ADDENDUM #5

Reference: Bingham Entrepreneurship & Engineering Center
Utah State University - Vernal - Utah
DFCM Project No. 08273770

Subject: **Addendum No. 5**

Addenda #5

SHEET TITLE
UTILITY PLAN

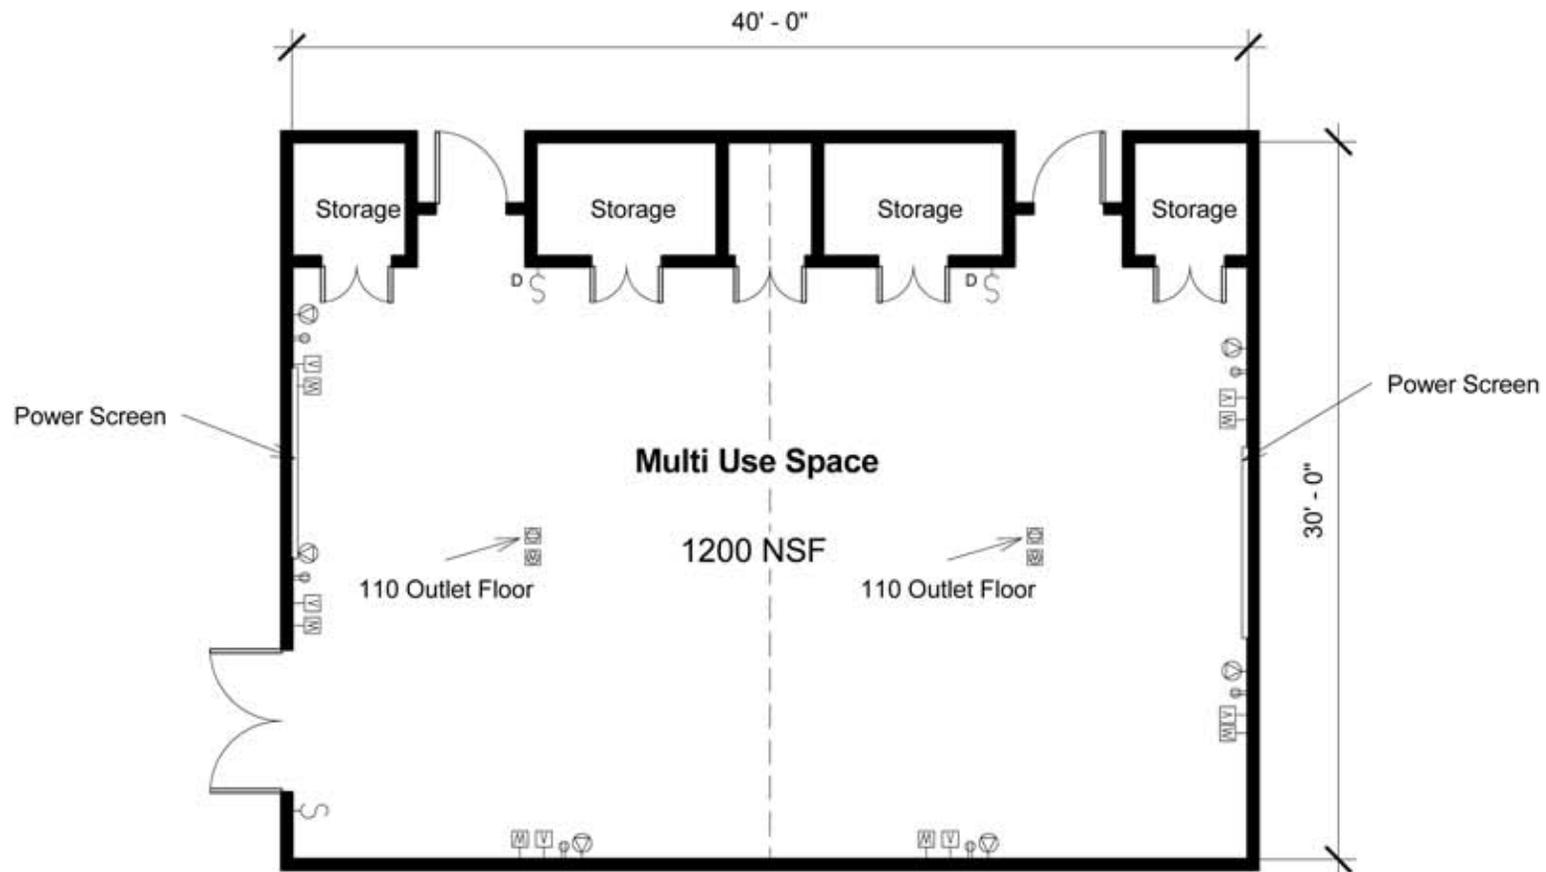
24: Need to attach latest storm drainage plan with inverts.

A: Sent out.

BC-TC2
Scale 1/8" = 1'-0"

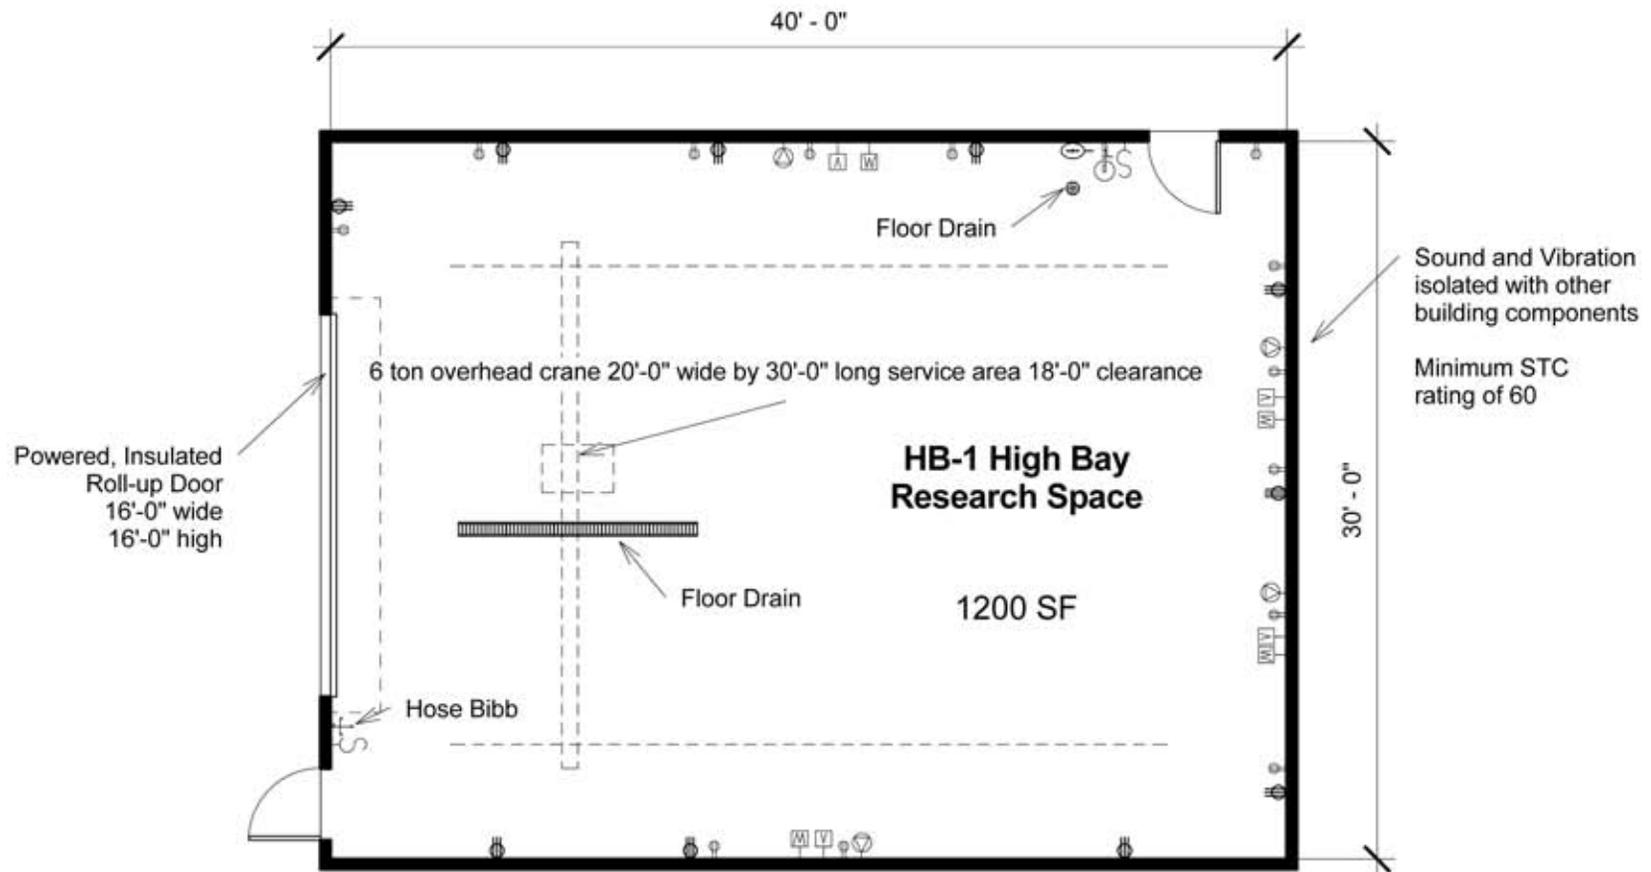
18: Additional space and changes in space to the Program. It is called the Research and Development Space. and will be approximately 1200 sq ft. It will be a high bay space (2 floors). The tiered lecture hall will now become the multi use space. It will be approximately 1200 sq ft for the use of group meetings, presentations and demonstrations. This space is to be finished in a higher décor than normal lecture space. See attached drawing.

Note: This is a replacement space for the Tiered, Lecture Hall (n~100) that was programmed at 46'-0" by 36'-0" = 1,656 NSF (old BC-TC2). Affinities and location criteria are the same for this space as the old BC-TC2.

Multi Use space for group meetings, presentations and demonstrations. Movable wall partition with panel storage area.

Finishes: Floor-carpet, walls-rubber base, painted sheet rock, ceiling-lay in acoustical ceiling at 10'-0" to 12'0"
